Ref: 171543/7529

RE: NEWCASTLE EAST PUBLIC SCHOOL - COUNCIL RFI (ACOUSTICS)

Figure 1. Eastern end of east-west section of proposal.

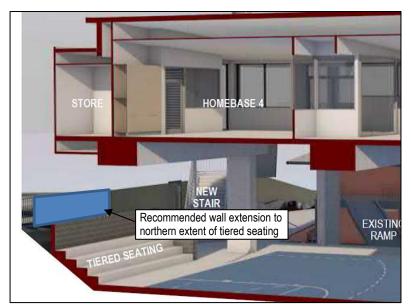
The proposed development has the potential to create adverse noise impacts on neighbouring receivers due to the addition of the proposed raised school building. The RSU notes that the introduction of the new school building above the existing sports area could potentially result in an increase in the transmission of noise due to reverberation along with line of sight to residential receivers.

Regarding propagation to the east, Figure 1 shows the eastern end of the section in drawing NE09. The play area is currently approximately 2m below the road surface of Brown Street and tiered seating as proposed, as indicated. The building above the play area will contribute to reverberant noise approximately the same as the existing roof structure, although transverse (horizontal) reflections my theoretically increase noise transmission to the east by 3 dB. This noise increase will be partly mitigated by the new tiered seating structure. Since this situation is not readily able to be modelled accurately, it is recommended that full mitigation of any potential additional reverberant noise propagation to the east will be achieved by extending the existing wall to the north as indicated in Figure 1 to cover the propagation path to the residential receiver.

In summary, the proposed structure itself is such that noise propagation to the west will not be increased. There is a theoretical possibility of small noise increase to the east, which would be mitigated by an extension of the existing boundary wall as indicated in Figure 1.
